Laurel SUITE ORIGINAL ONLY. (102)

CONSTRUCTION SUMMARY
Hampton Place

Unit 102	Model LAUREL (2J)	Street 25 Baker Hill Blvd.	Date Ordered 22-Jun-2017
-------------	----------------------	-------------------------------	-----------------------------

HAMPTON SUITE 102

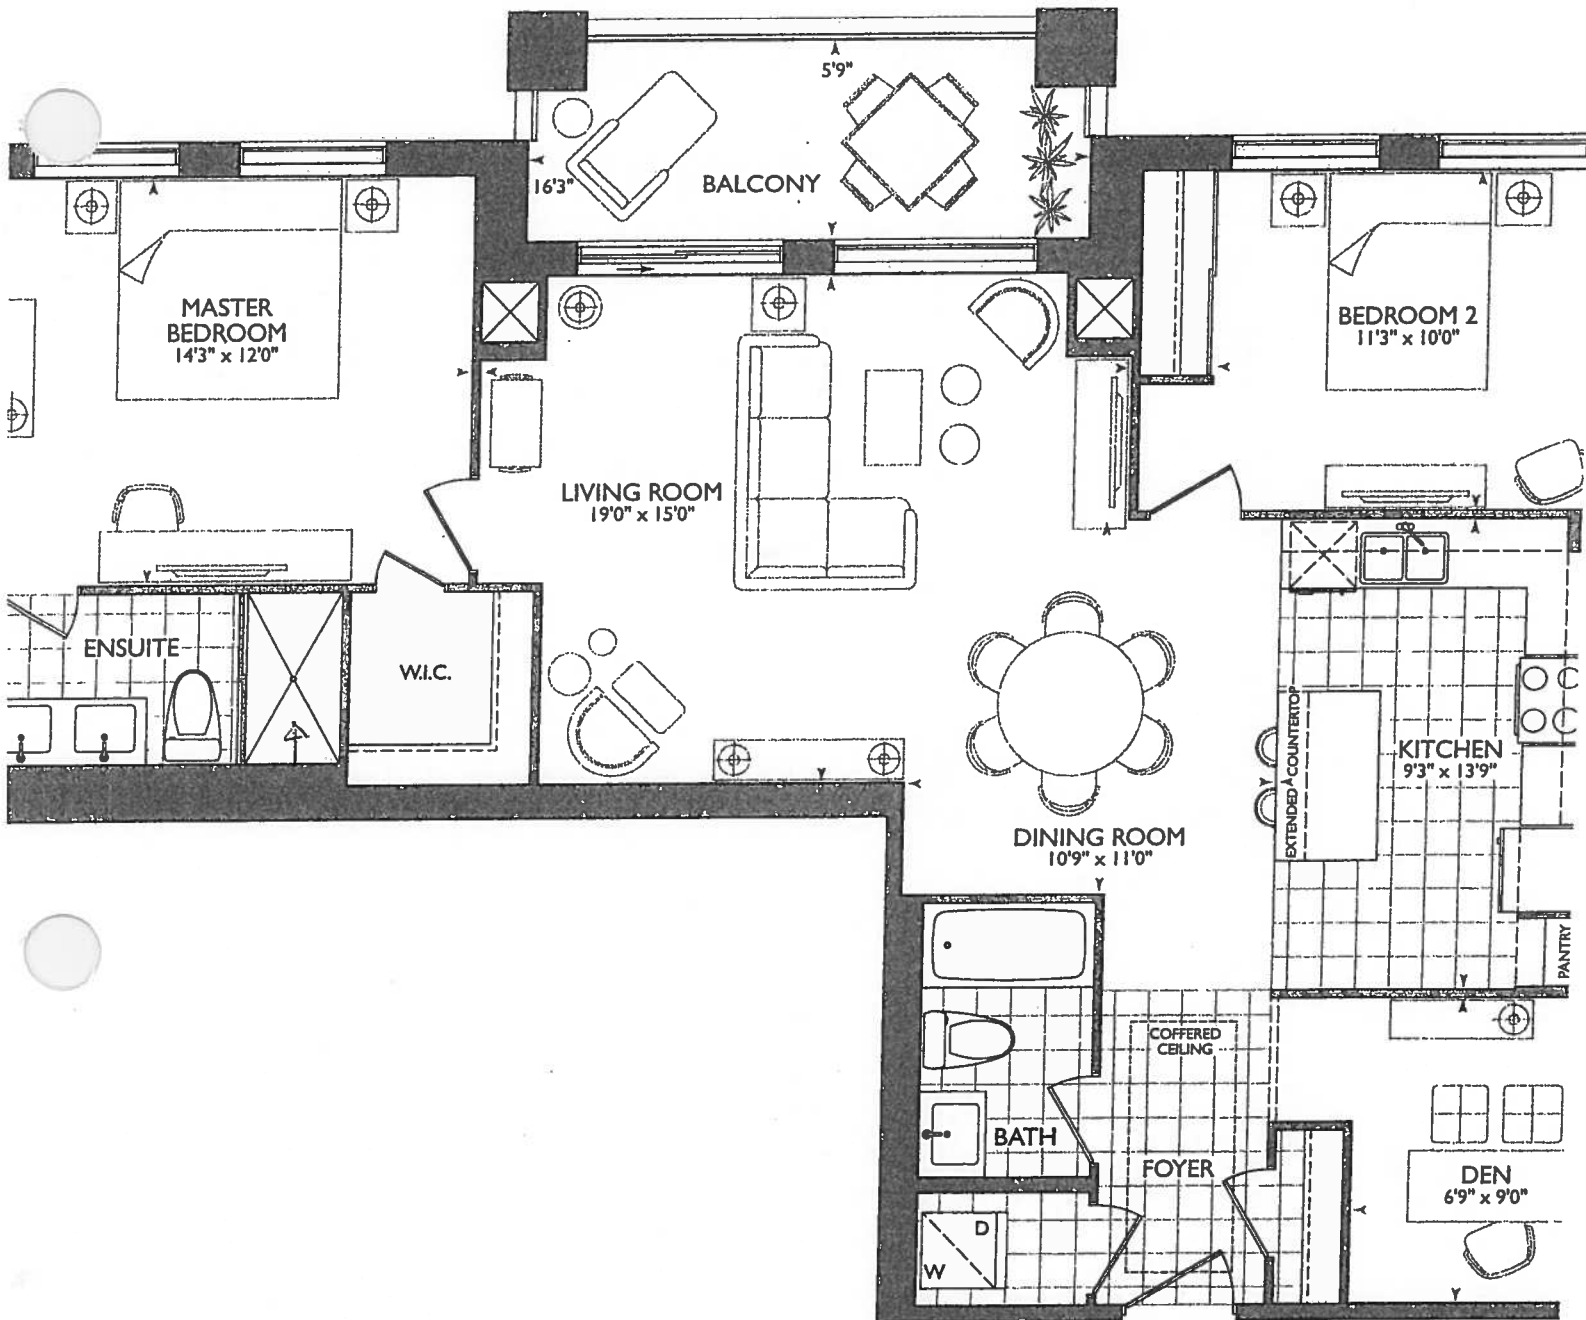
- CHIMNEY HALL PIPE CENTRE 69"
- UP6D APPLIANCE PACKAGE 3A.
(BUILT IN APPLIANCES)
- (X2) PLUGS ISLAND
- KITCHEN POTS ÷ PENDANT LIGHTS
SEE KITCHEN LAYOUTS

- * (x4) Extended Height Doors
- * H11N + ENSUITE RAISED VANITY HEIGHTS 36 1/4" @ NO 3" splash

**NO shelving
NO ceramic
accessories
NO mirrors
THROUGH OUT**

**RELOCATE THE ELECTRICAL
& PLUMBING LOCATIONS
LOCATION OF KITCHEN
LIGHTS REFER TO QTK. DWG.**

⑤ = Plug N. Bedroom Future Fireplace

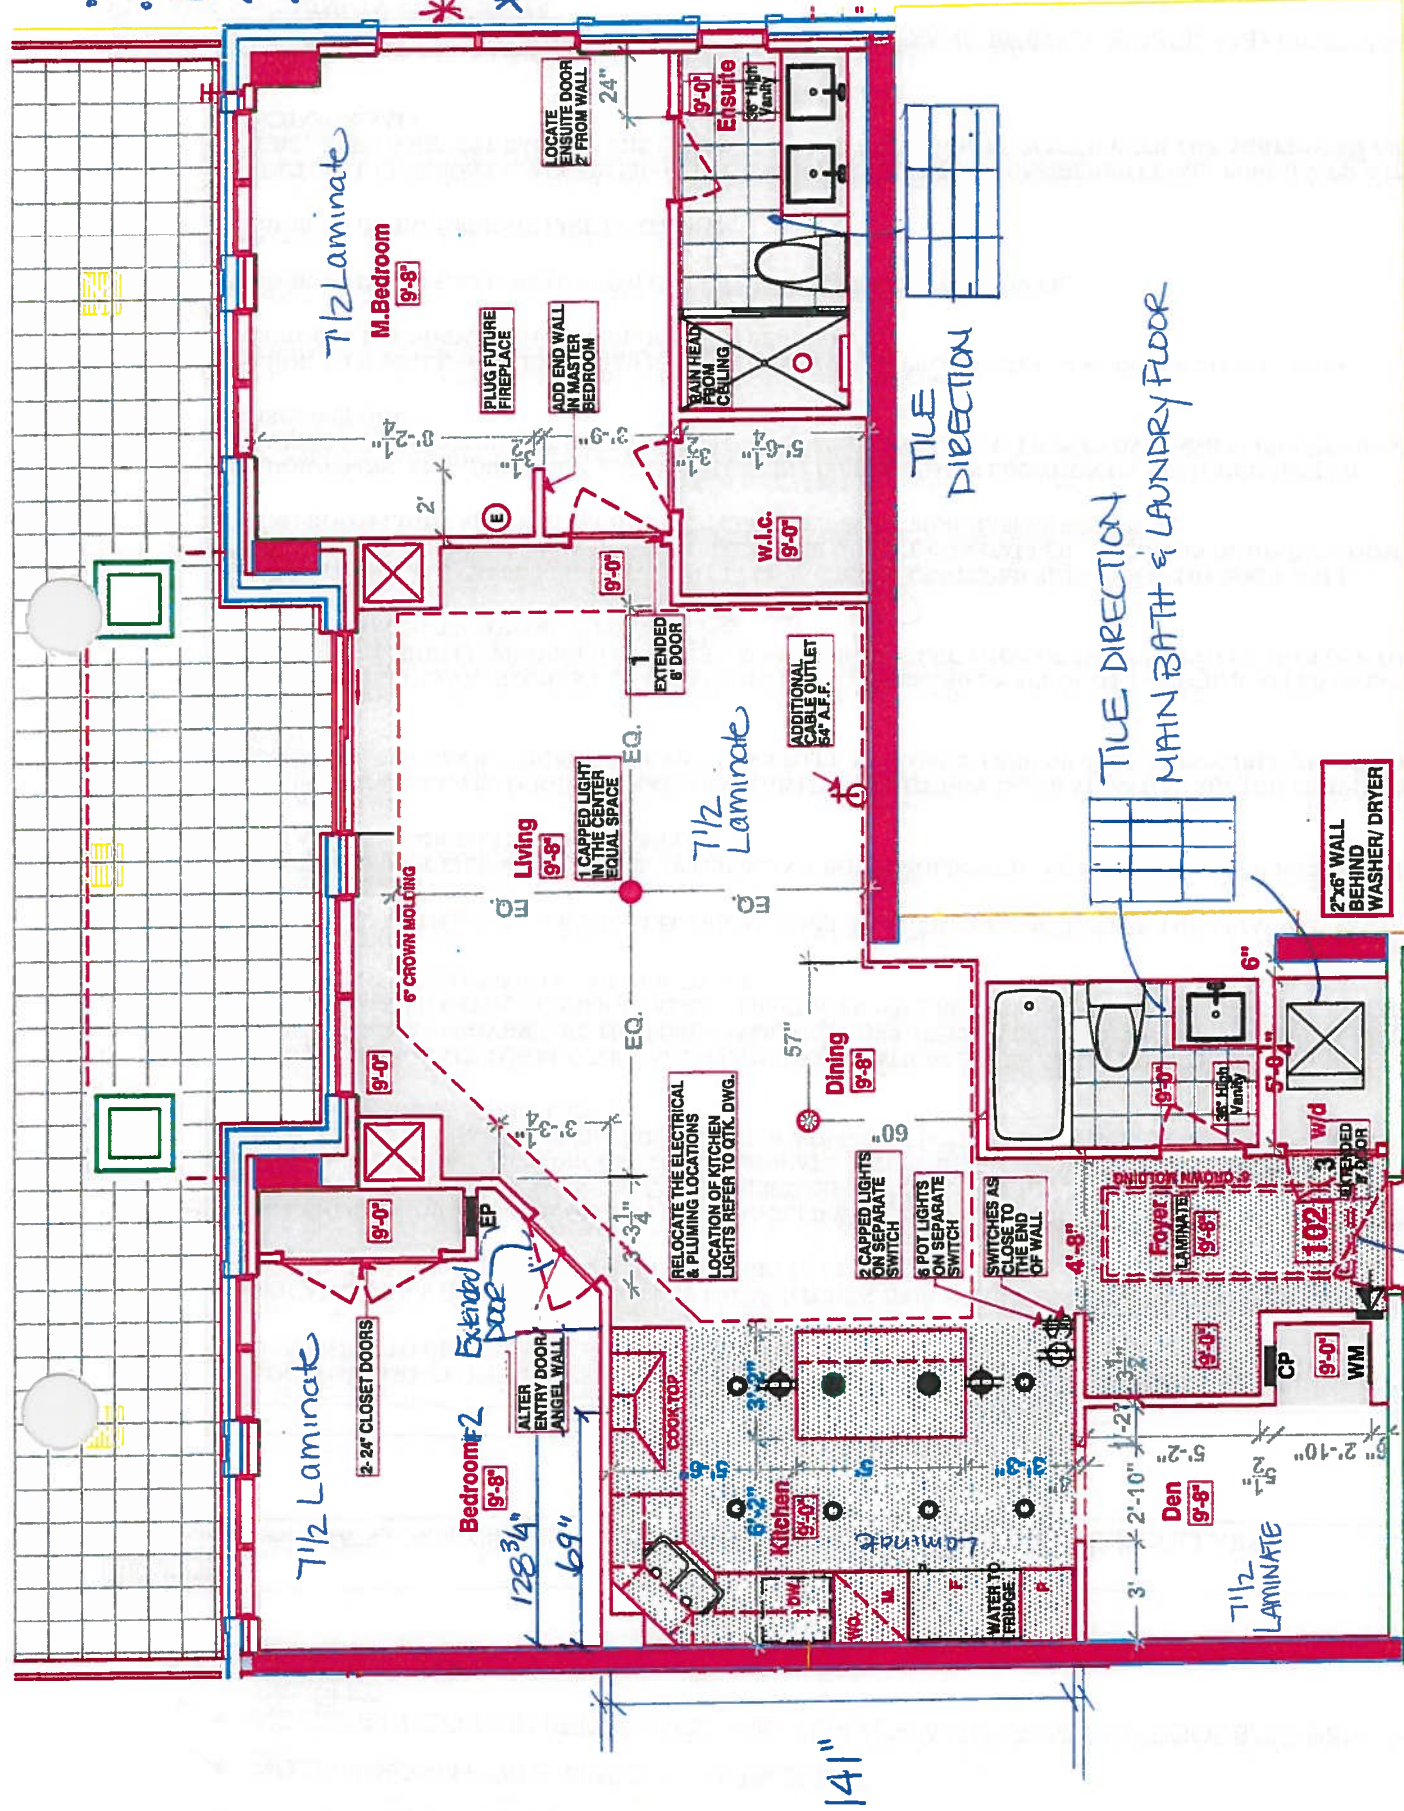
71/2 LAMINATE

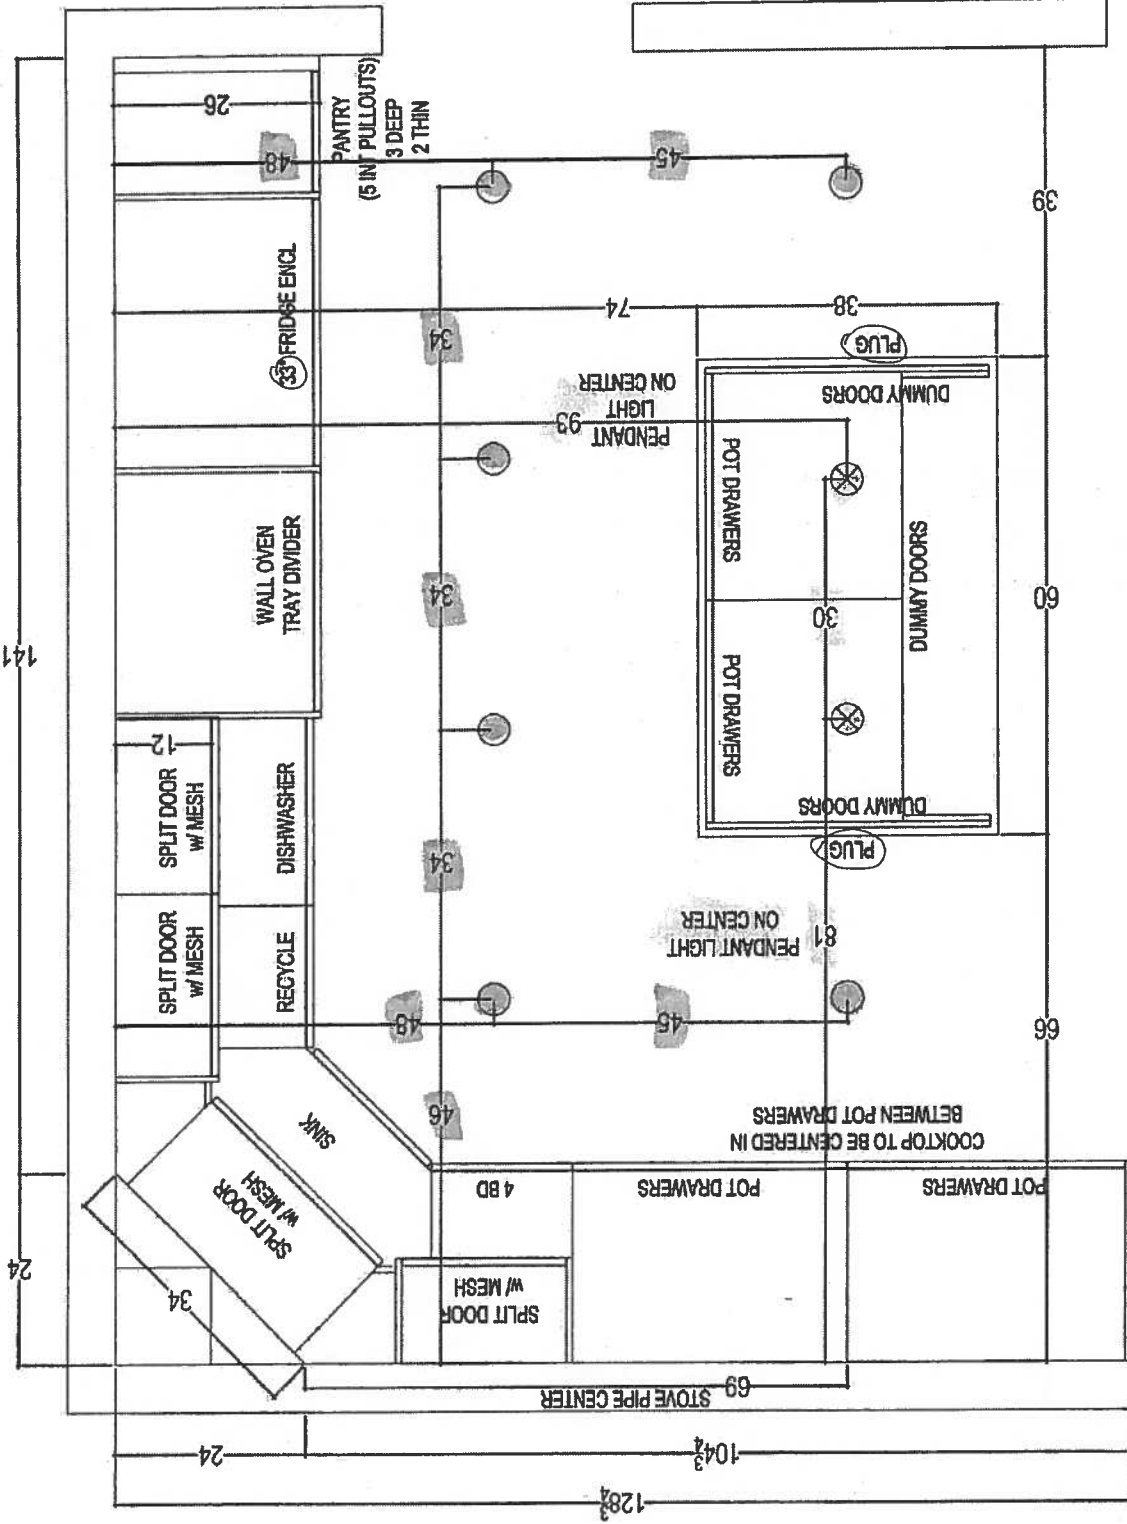
- PL = PUCK LIGHTS
(5x) LOWER
(5x) UPPER
TOTAL = 10x
- CHIMNEY HOOD FAN
- 6x = POT LIGHTS
- 2x = PENDANT LIGHTS
- 2x = ISLAND PLUGS
- Appliance.
PACKAGE # 3A.

MAN + ENSURE
RANGE VANITIES
36" x 48" x 3"
SPLASH.

HAMPTON
SUITE 102.

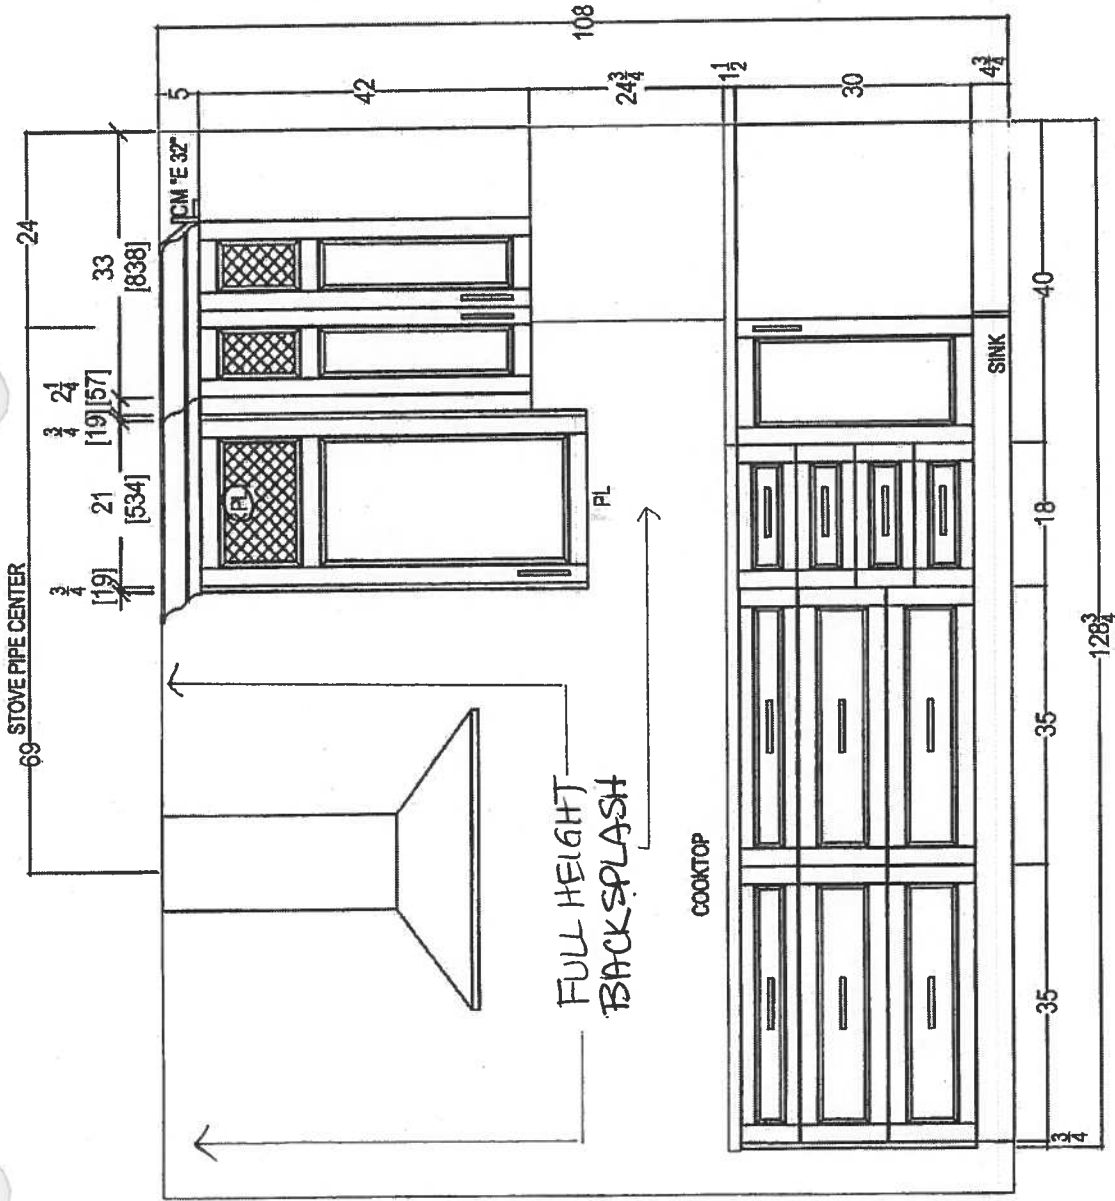
- PL = PUCK LIGHTS
- (XS) UPPER PUCKS
- (XS) LOWER PUCKS
- TOTAL PUCKS (x10)

HAMPTON SUITE 102

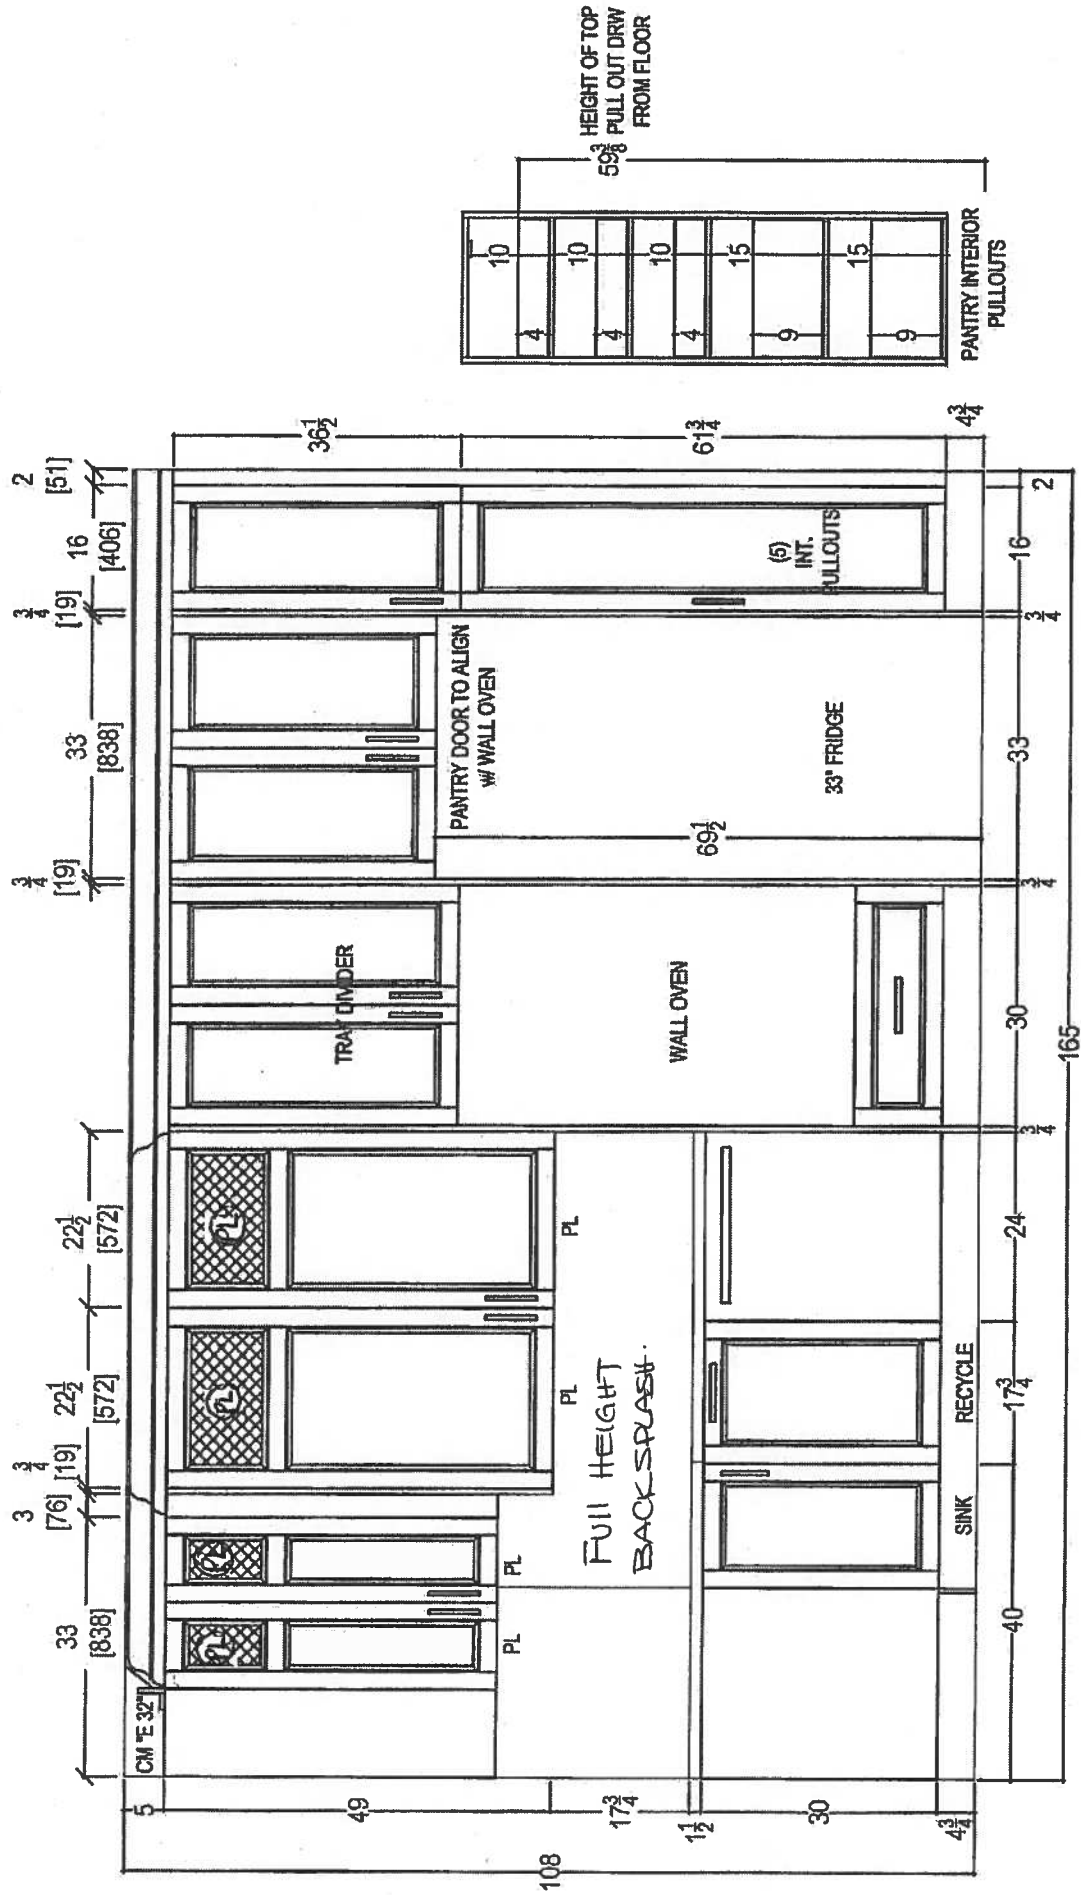
PL = Puck Lights

Total (x10) Pucks

(x5) Upper

(x5) Lower

HAMPTON SUITE 102

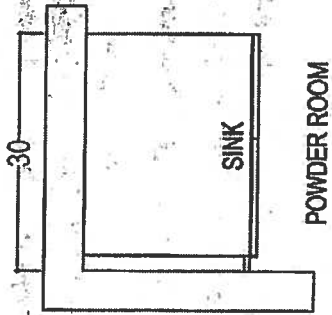
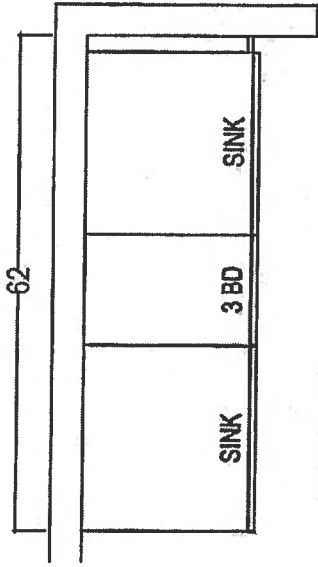
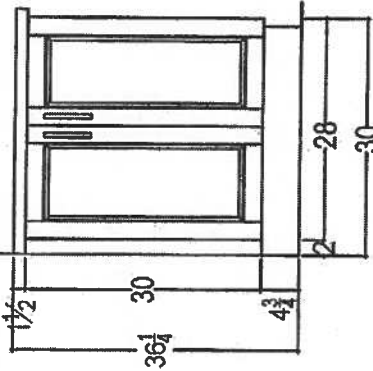
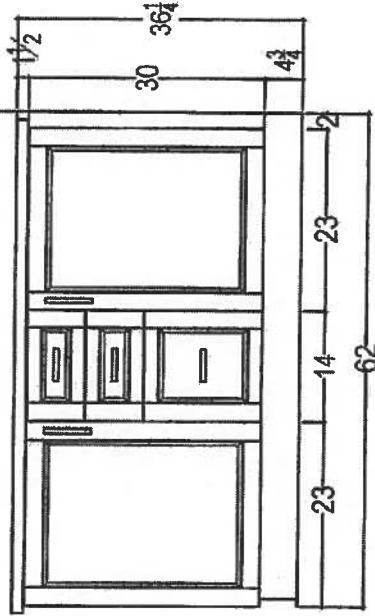
* DELETE 3" SPLASH *

* DELETE 3" SPLASH *

* RAISED VANITY *

* RAISED VANITY *

* HAMPTON *

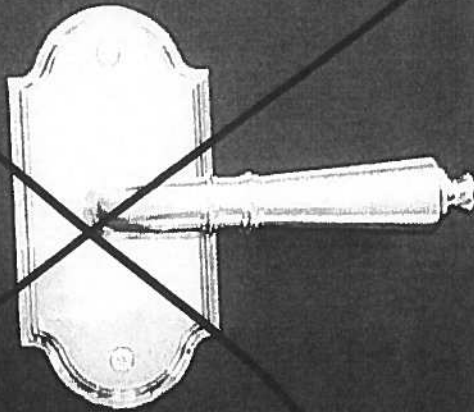
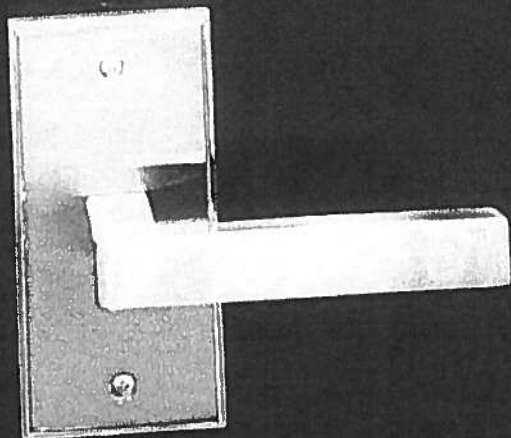
~~Traditional
AURUM MR390M42~~

MODERN

AURUM AUR TIDEK
